City of Huntington Beach Planning Department  
**STAFF REPORT**

**SUBJECT: APPEAL OF THE ZONING ADMINISTRATOR'S APPROVAL OF COASTAL DEVELOPMENT PERMIT NO. 07-018 AND CONDITIONAL USE PERMIT NO. 07-044 (HERMAN RESIDENCE – Continued from the May 27, 2008 meeting)**

**LOCATION:** 3292 Falkland Circle, 92649 (terminus of Falkland Circle., east of Channel Lane – Admiralty Island)

**THIRD FLOOR PLAN**

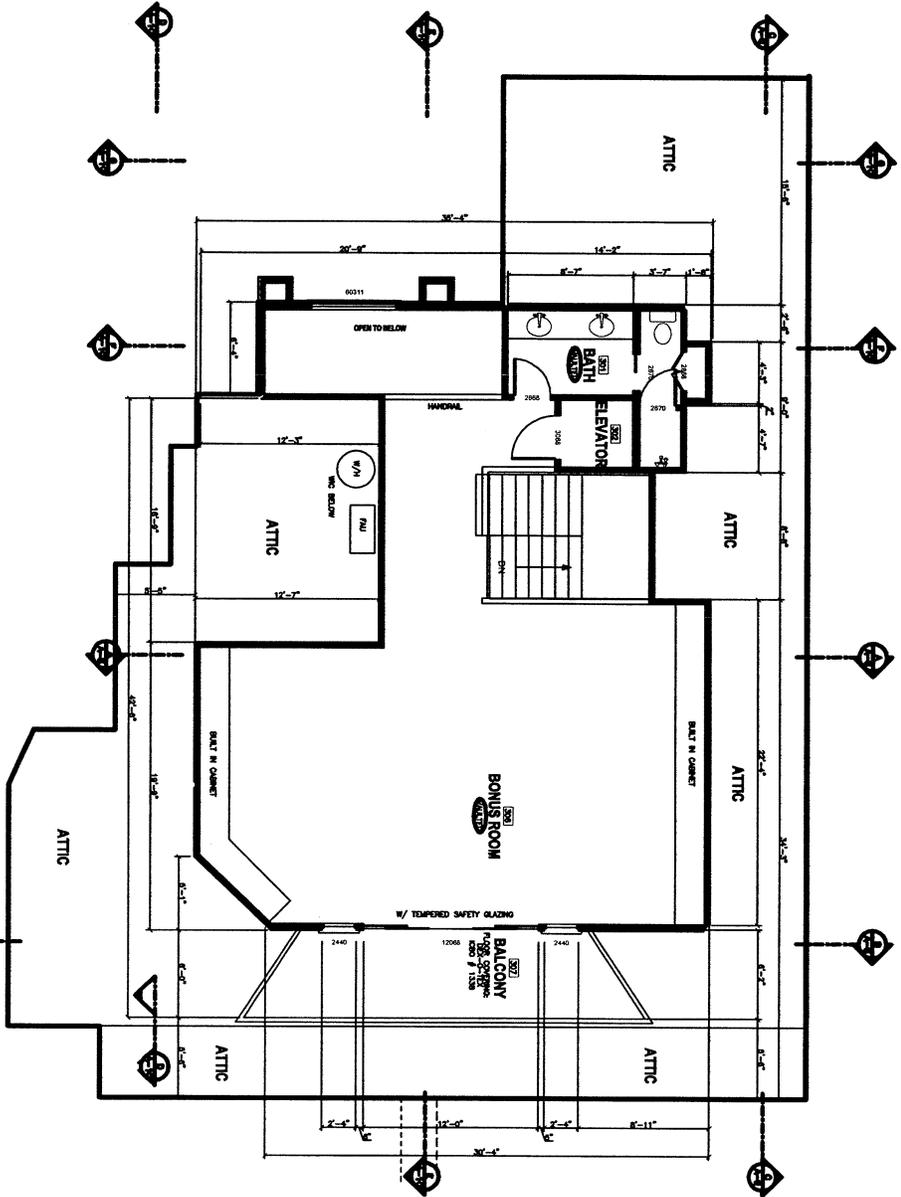
The proposed residence will include a 1,107 sq. ft. third floor which is referred to as a "bonus room" on the submitted floor plan and 1,793 sq. ft. of non-accessible attic space. Uncertainty as to the classification of this room was expressed at the meeting. Based on the HBZSO definition any room used principally for sleeping purposes, an all-purpose room, a study, a den, a room having 100 sq. ft. or more of floor area or less than 50 percent of one wall open to an adjacent room or hallway is considered a bedroom. In this instance, more than 50% of the proposed third floor walls are open to the adjacent staircase/landing and the second floor hallway area. Since the third floor habitable area does not fulfill the aforementioned criteria, no additional parking space is required.

The third floor bonus room is with in the second story roof element as described by code and the deck has been set back five feet. The deck's line of sight is the public waterway as shown on the site plan A-1.

- a. All drawings (plans, sections) shall depict all portions of the third floor bathroom with a five ft. minimum setback from the second story façade, consistent with the third floor plan received March 28, 2008 and identified as “Exhibit A”.

EXHIBIT A  
 RECEIVED MAR 28 2008

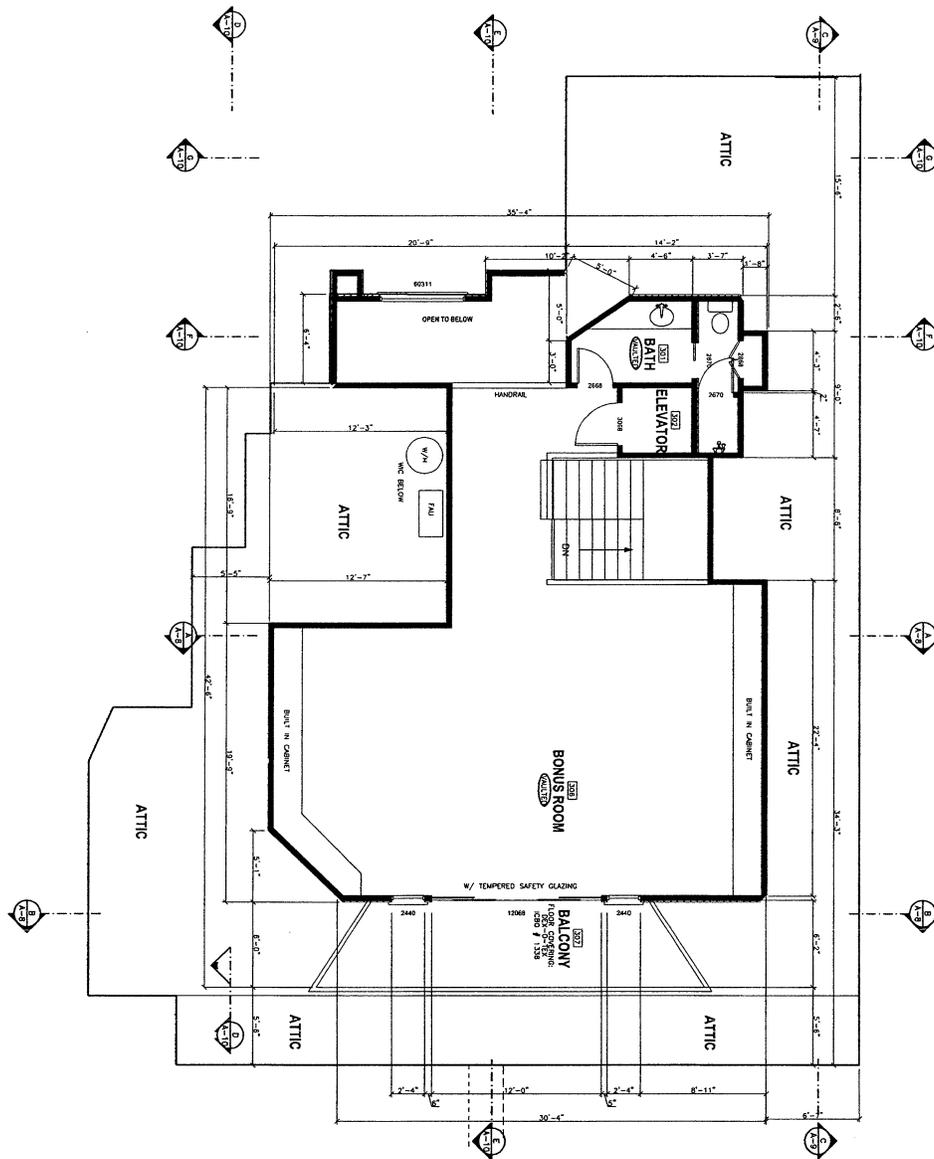
- a. All drawings (plans, sections) shall depict all portions of the third floor bathroom with a five ft. minimum setback from the second story façade, consistent with the third floor plan received March 28, 2008 and identified as “Exhibit A”.

ALTERNATIVE 1

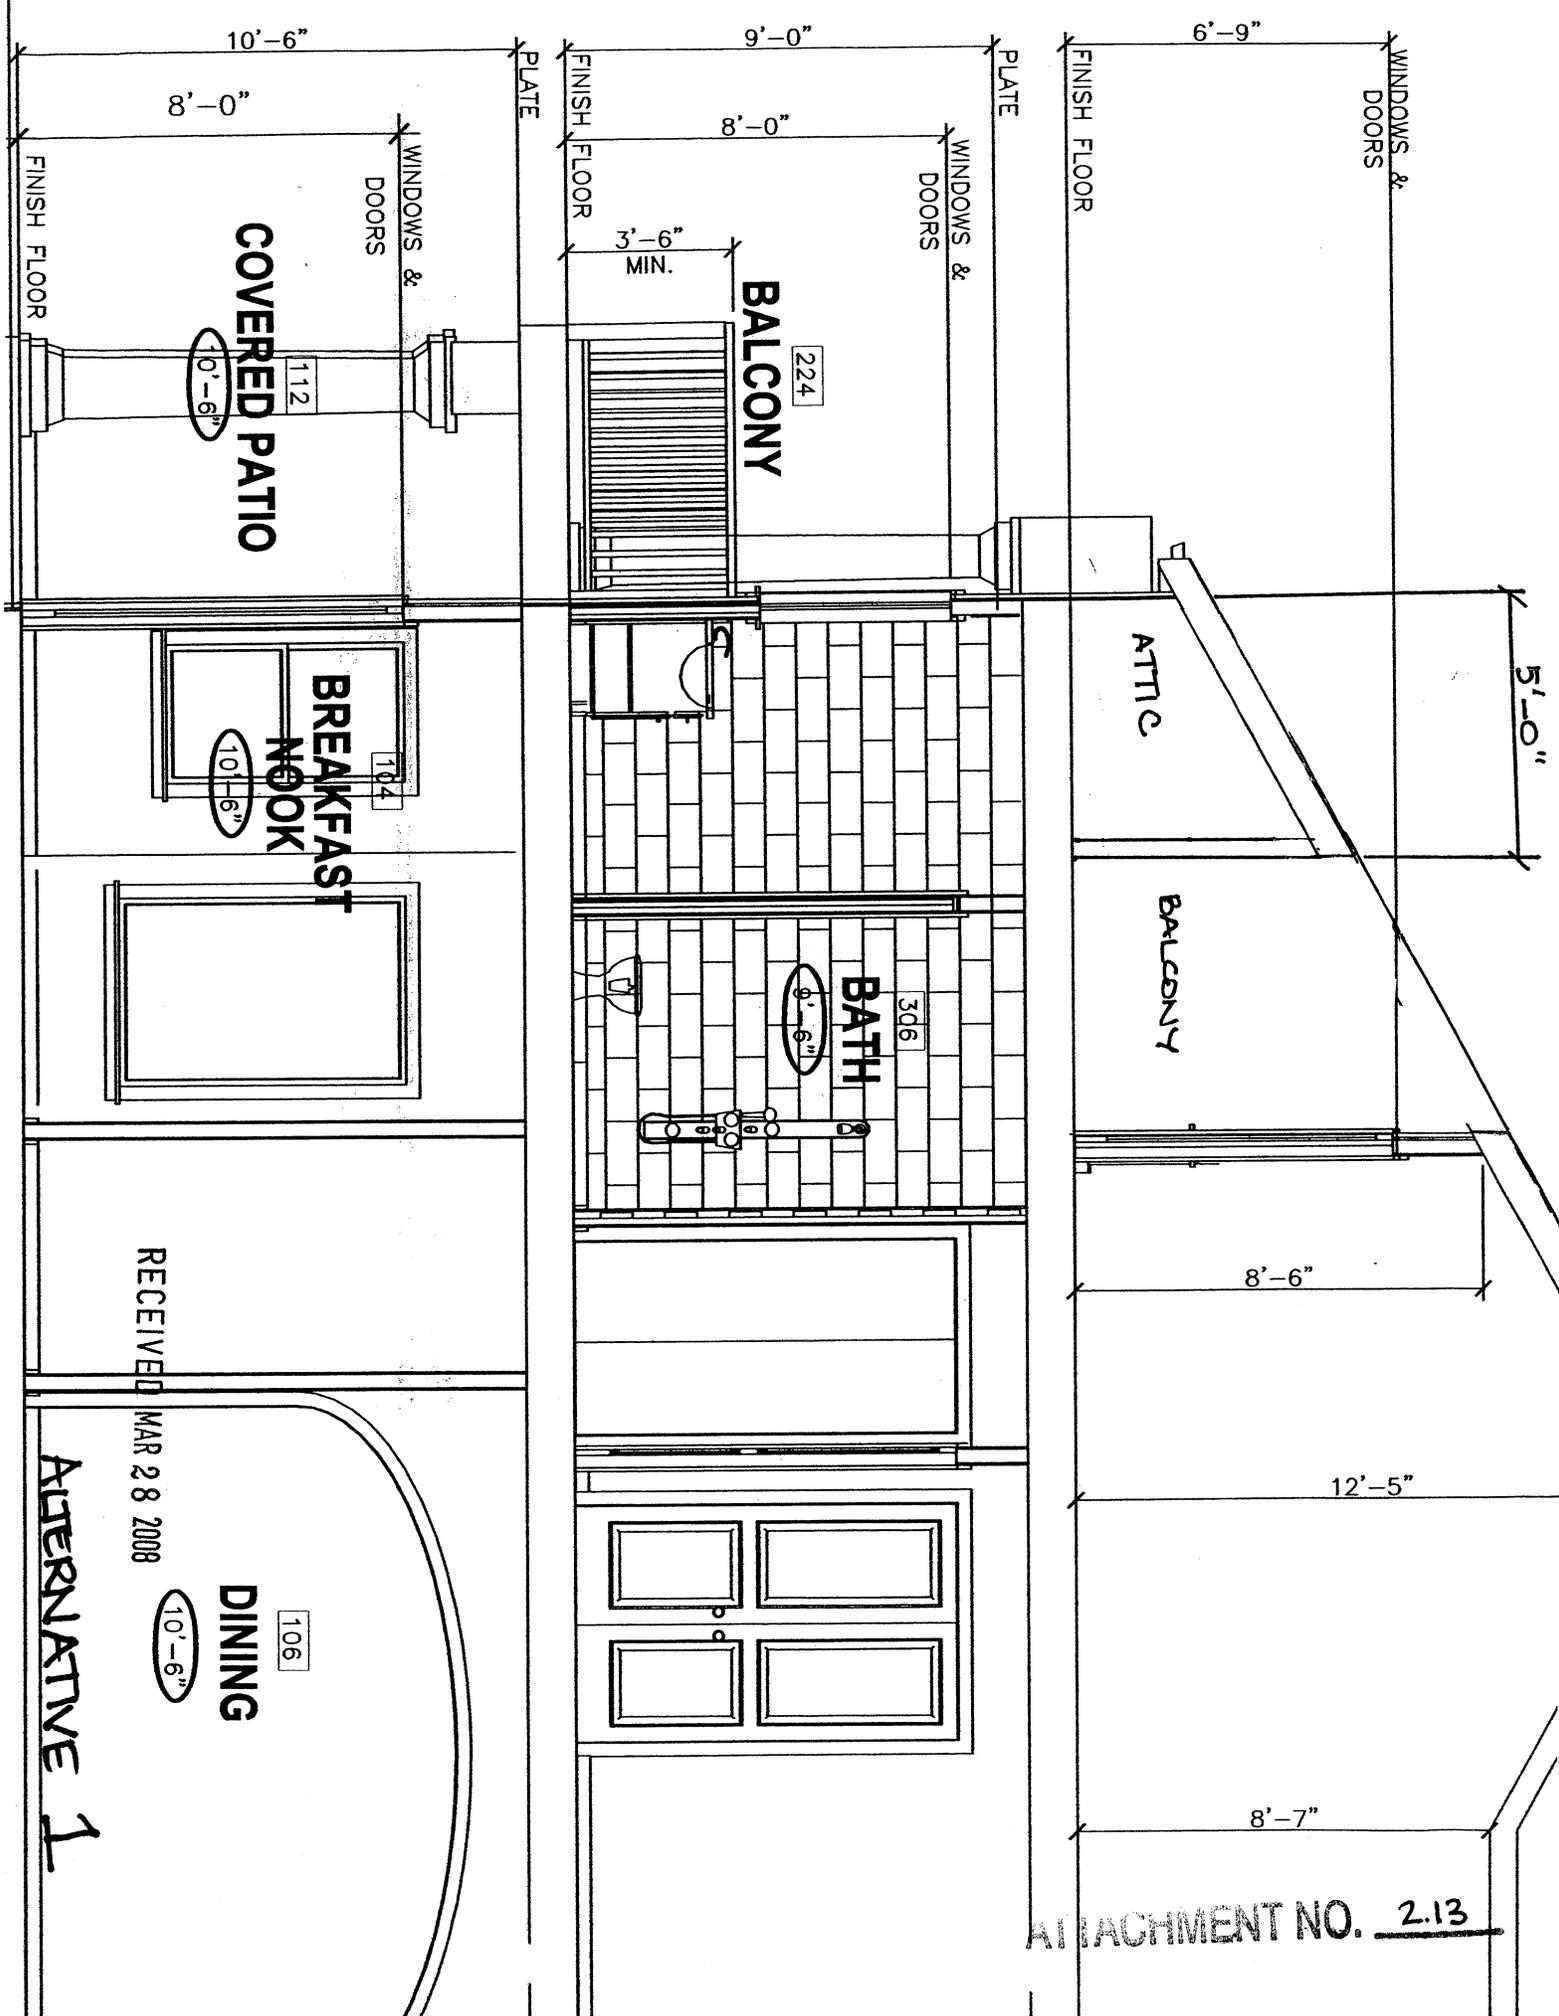
- b. All drawings (plans, elevations, sections) shall depict the third floor balcony with a five ft. minimum setback from the second story façade consistent with one of the section drawings received March 28, 2008 and identified as “Alternative 1”, “Alternative 2”, and “Alternative 3”.

- b. All drawings (plans, elevations, sections) shall depict the third floor balcony with a five ft. minimum setback from the second story façade consistent with one of the section drawings received March 28, 2008 and identified as “Alternative 1”, “Alternative 2”, and “Alternative 3”.
